April 4, 2014  
ES/NRC 14-006  
Docket No. 72-1007

**Subject: Response to Request for Additional Information for the VSC-24 CoC  
Renewal Application (TAC No. L24694)**

**Summary of Changes, Certificate of Compliance Renewal Application  
 for the VSC-24 Ventilated Cask Storage System, Revision 2**

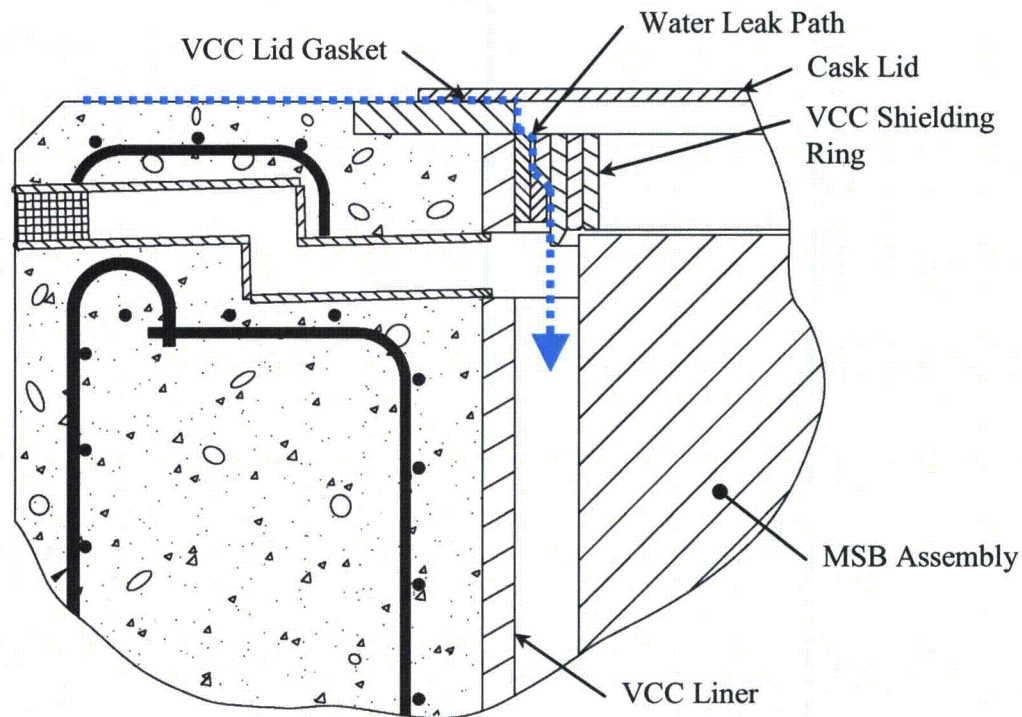
*RAI-3. Provide a TLAA for the polymeric gaskets used for the weather covering and explain how the TLAA will be verified through inspections and justify the frequency of inspections. Alternatively, justify that failure of the polymeric gaskets will not lead to accelerated corrosion of the VSC-24 exteriors.*

*Polymeric materials, even if not in the presence of a radiation field, will embrittle, creep, and degrade over time. The staff finds that polymeric gasket materials may not function as intended over a 60-year lifespan. The integrity of the weather cover establishes the conditions for the aging management of the system and thus needs a TLAA.*

The VCC lid gasket lies in a sheltered environment with very low radiation levels. Only the inside and outside edges of the VCC lid gasket are directly exposed to an oxidizing atmosphere. Therefore, minimal degradation of the VCC lid gasket is expected to occur during the extended storage period. Unless the VCC lid gasket is disturbed, it is not expected that the lid gasket will allow any water to leak into the VCC cavity. The most likely disturbance of the cask lid is if the bolts and lid are removed, but as discussed in the response to RAI-20, the old lid gasket is required to be replaced with a new lid gasket the prior to re-installation of the cask lid, regardless of condition of the old lid gasket. Therefore it is highly unlikely for the lid gasket to degrade and leak. Nonetheless, in the unlikely event that degradation of the VCC lid gasket material results in a water leak, the design of the VCC shielding ring plates will direct water flow down the VCC annulus and prevent water from accumulating on the top of the MSB assembly, thereby preventing the possibility of accelerated corrosion of the MSB structural lid and closure weld.

The VCC shielding ring is placed on the top of the cask liner assembly after the MSB assembly is lowered into the VCC cavity. It fits loosely inside the cask support rings at the top of the cask liner and extends over the top corner of the MSB assembly. As shown in the figure below, any water that leaks through the VCC lid gasket will be directed down the annular gap between the cask liner and VCC shielding ring, where it will drip to the bottom of the VCC annulus, and will not collect on the MSB structural lid, thereby preventing accelerated corrosion of the MSB lid or welds. Any significant amount of water that drips to the bottom of the VCC annulus will drain out the VCC inlet channels. The carbon steel surfaces of the VCC liner and MSB assembly that form the VCC annulus are coated for corrosion protection. Moisture that accumulates on the coated surfaces of the VCC liner and MSB shell will evaporate or drain out of the VCC assembly. Therefore, failure of the VCC lid gasket is not expected to lead to accelerated corrosion of the VCC liner and MSB shell.

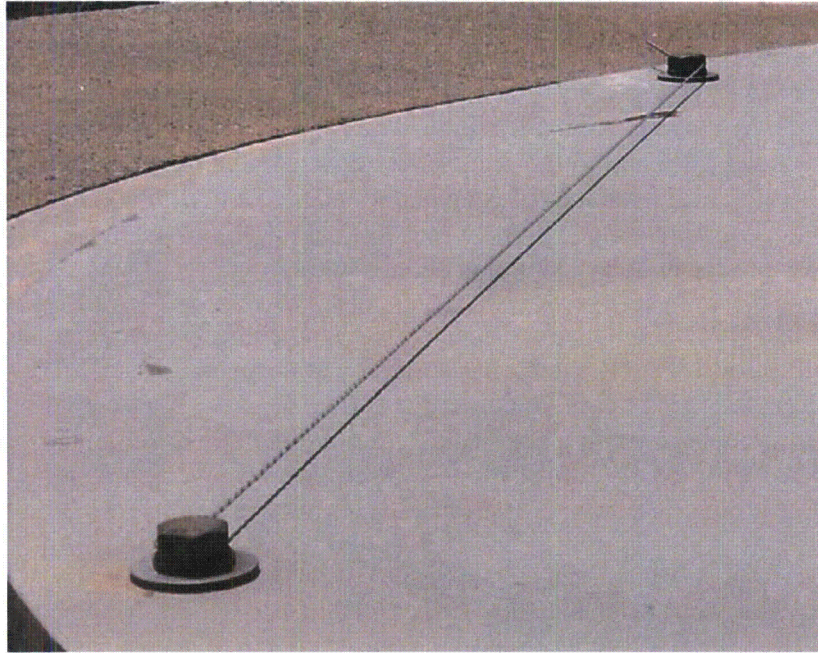
*RAI-9. Provide a corrosion analysis with the predicted corrosion rate for the VCC bolts over the 40-year renewal period. Explain how the predicted corrosion rate is determined and verified through inspections and justify the frequency of inspections.*

The VCC lid bolts are made from A307 carbon steel with a zinc coating or other protective finish. The protective finish on the VCC lid bolts is intended to inhibit corrosion. However, the VCC lid bolts may experience some corrosion during the extended storage period, as operating experience shows. As noted in the Palisades Lead Cask Inspection Report, when the VCC lid bolts were removed, some corrosion was identified on the bolts. However, as shown in the picture below, the amount of corrosion on the VCC lid bolts of the Palisades lead cask was limited to local discoloration of the surface finish, and as such, they were determined to be acceptable for continued use.

Potential aging effects in the VCC lid bolts are managed by AMP, not TLAA. The AMP requirements for managing aging effects in the VCC lid bolts are discussed in the response to RAI-20.
